Access Compliance Report

Public Rights-of-Way

(Curb Ramps)

Intersection ID: 31206	Main Street: WESTBURY_GLEN_CT	Cross Street: LARIMER_LN	Location: E
ADA ID: D0B259ECA3EF	Ramp Type: PerpDiag	Initial Pass/Fail: Fail	Overall Compliance: No
Codes/Mitigation Info/Possible Solution		Field Measurements/Component Compliance

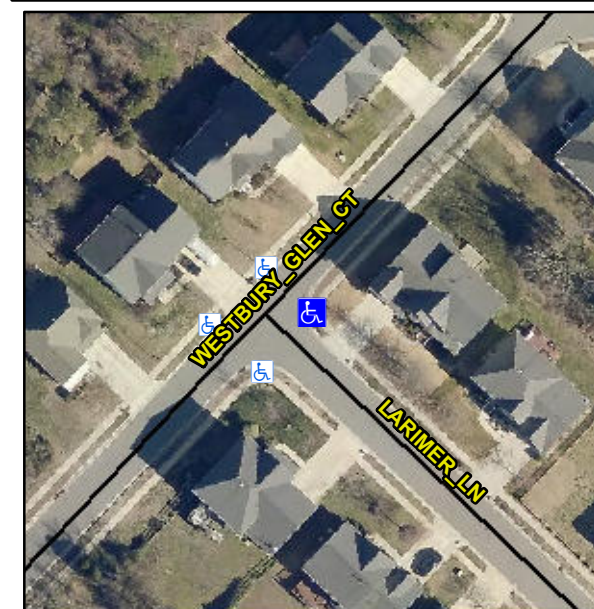
Not Found, R304.5.1, R304.5.3

Compliance	Description	Data	Compliance	Description	Data
N/A	Ramp Length (in)	48.0	Yes	Ramp Slope (%)	5.0
No	Ramp Width (in)	40.0	No	Ramp XSlope (%)	8.6
N/A	Flare Type LT	N/A	N/A	Flare Type RT	N/A
N/A	Flare Slope LT (%)	N/A	N/A	Flare Slope RT (%)	N/A
N/A	Flare Traversable LT?	N/A	N/A	Flare Traversable RT?	N/A
N/A	Landing Length (in)	N/A	N/A	DWS Provided?	N/A
N/A	Landing Width (in)	N/A	N/A	DWS Contrast?	N/A
N/A	Landing Slope (%)	N/A	N/A	DWS Length (in)	N/A
N/A	Landing X Slope (%)	N/A	N/A	DWS Full Width?	N/A
N/A	Landing Curb? (Y/N)	N/A	N/A	DWS Offset (in)	N/A
N/A	Shared Landing?	N/A			
N/A	Gutter Ponding?	N/A	N/A	Gutter Slope (%)	N/A
N/A	Gutter Lip Ht (in)	N/A	N/A	Gutter X Slope (%)	N/A
N/A	Painted X Walk1?	No	N/A	Painted X Walk2?	No
	X Walk 1 Direction	To NW		X Walk 2 Direction	To SW
N/A	X Walk 1 Width (in)	N/A	N/A	X Walk 2 Width (in)	N/A
	X Walk 1 Slope (%)	0.8		X Walk 2 Slope (%)	9.0
	X Walk 1 X Slope (%)	8.3		X Walk 2 X Slope (%)	4.6

Remove & Replace Curb Ramp With Two New Directional Ramps or Equivalent.
